UNITED STATES PATENT AND TRADEMARK OFFICE

10/510,994

Office Action Summary

DETAILED ACTION

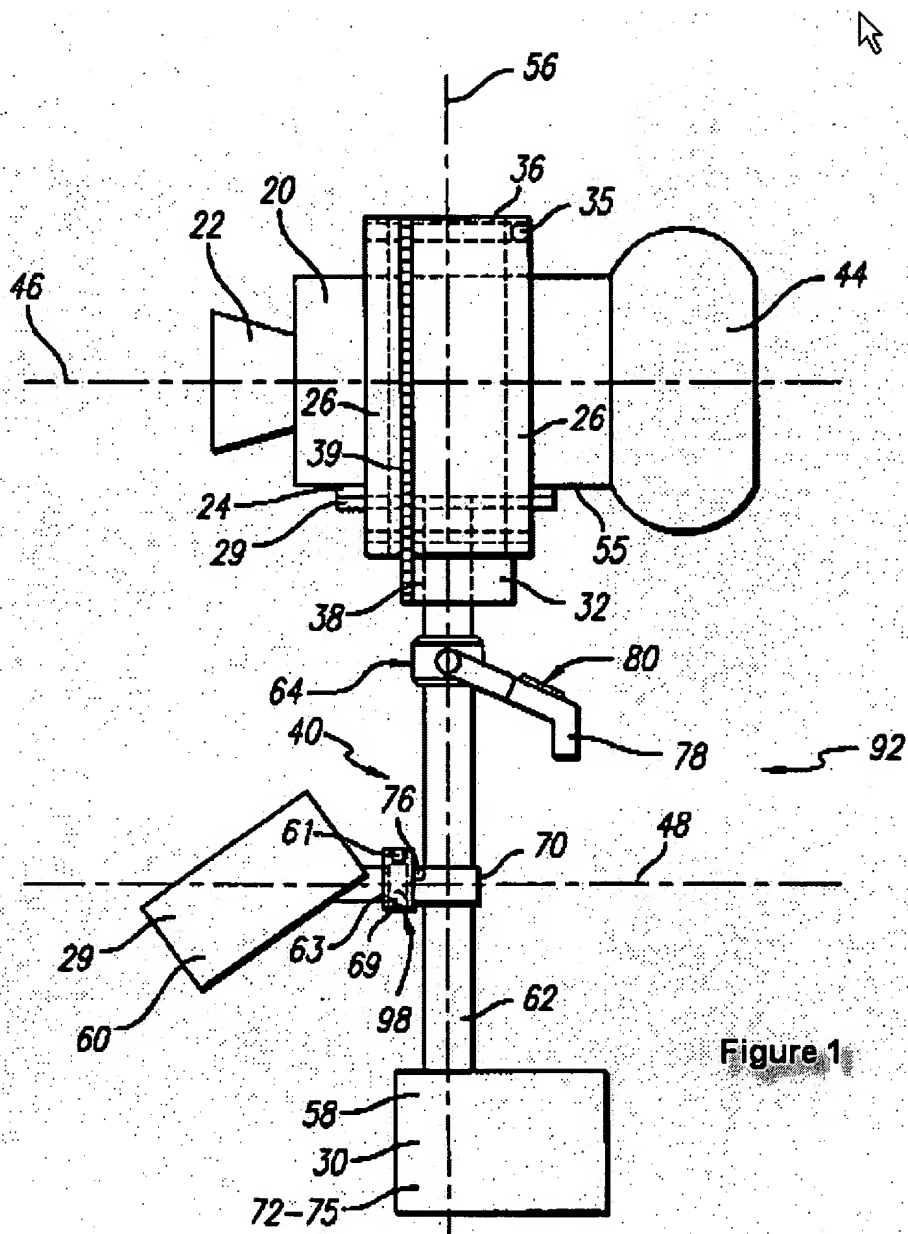
Claims 14-17, 19-21 are rejected under 35 U.S.C. 102(b) as being anticipated by Nicholson(US5963749). Referring to figure 1 and in regards to claim 14, Nicholson discloses a camera support which supports a camera from below its center of gravity and allows relative rotation between the support and the article about a predetermined axis, in this case along the optical axis of the camera. In regards to claim 15 the predetermined axis is definable and would change with horizontal location of the support. In regards to claim 16 in figure 1, the support has first and second portions 29 and 32 whereby the camera is eccentrically mounted on portion 29 and portion 32 can rotate while the camera remains stationary. In regards to claim 17 the camera can rotate around its optical axis while remaining aligned with said axis. In regards to claim 19 Nicholson discloses in C9 L24-52 that a motor is used to provide rotation between the first and second portions. In regards to claim 20 and referring to figure 2, element 38 is a pinion gear that can be engaged in combination with “.. gear/belt/chain 39 or similar means.”(C9 L47-48) which is on the first portion. In regards to claim 21 the rotational axis is aligned with the camera optical axis.

Figure 2

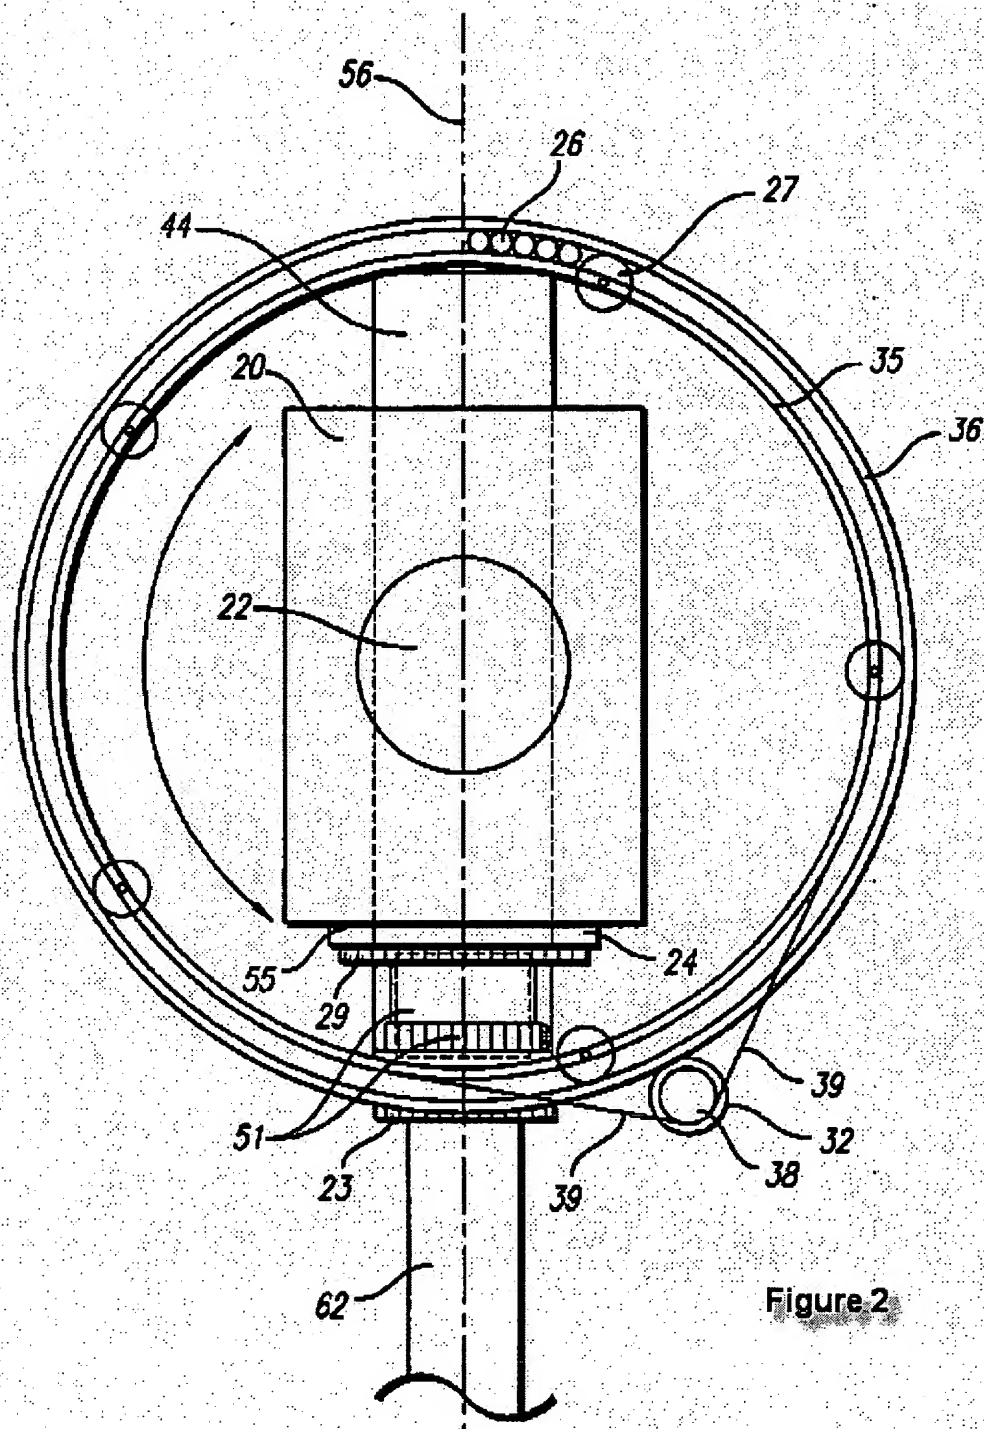
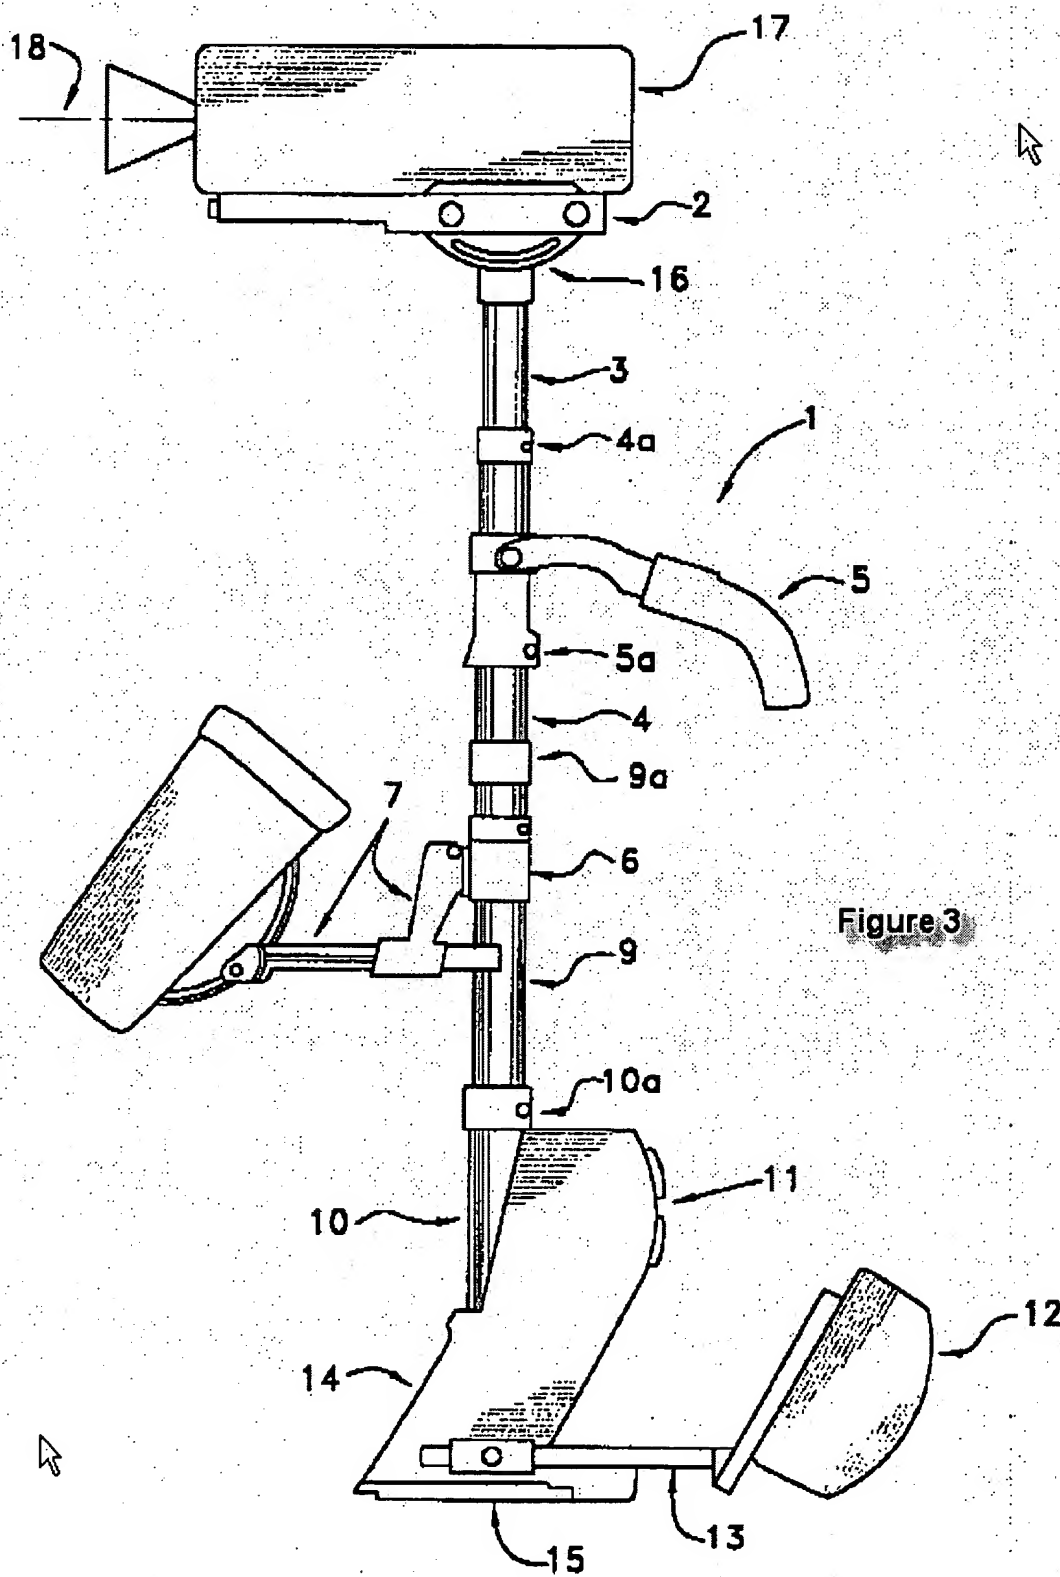
Claim 26 is rejected under 35 U.S.C. 102(b) as being anticipated by Holway(US6293676). Referring to figure 3, Holway teaches a camera support with a

first elongate post section(4) a second elongate post section(3) adapted at one end to mount an article, further adapted to telescopically engage the first post section, a third post section(9) telescopically engaged with the first post section, and a fourth elongate post section 10 adapted to support a load (12) and a gimbal unit located between the ends of the first post section, which further allows pivotal movement between the support means(12 or 10) and the unit posts sections.

Claims 22-25 are rejected under 35 U.S.C. 103(a) as being unpatentable over Nicholson(US5963749) in view of Holway(US6293676). In regards to claim 22 Nicholson teaches all the preceding limitations as detailed above, however Nicholson does not teach a main post section with at least two telescopically engaged post sections that can be independently positioned with respect to opposite sides of the first section. Holway teaches such a telescoping post as described above and shown in figure 3. It would have been obvious to one of ordinary skill in the art at the time of invention to combine the rotatable camera support means of Nicholson with the telescoping post of Holway to make a camera support which could provide rotation about a predetermined axis and having a telescoping post section to replace the nontelesoping post section of Nicholson. Referring to figure 3, and in regards to claims

23-25, the telescoping posts of Holway further comprise position adjustment elements (4A and 9A) coupled to the main post section, a gimbal unit(5) with a sleeve that is lockable by element 5A to the main post section, which further comprises a pivotally mounted support handle(5) on said gimbal unit.
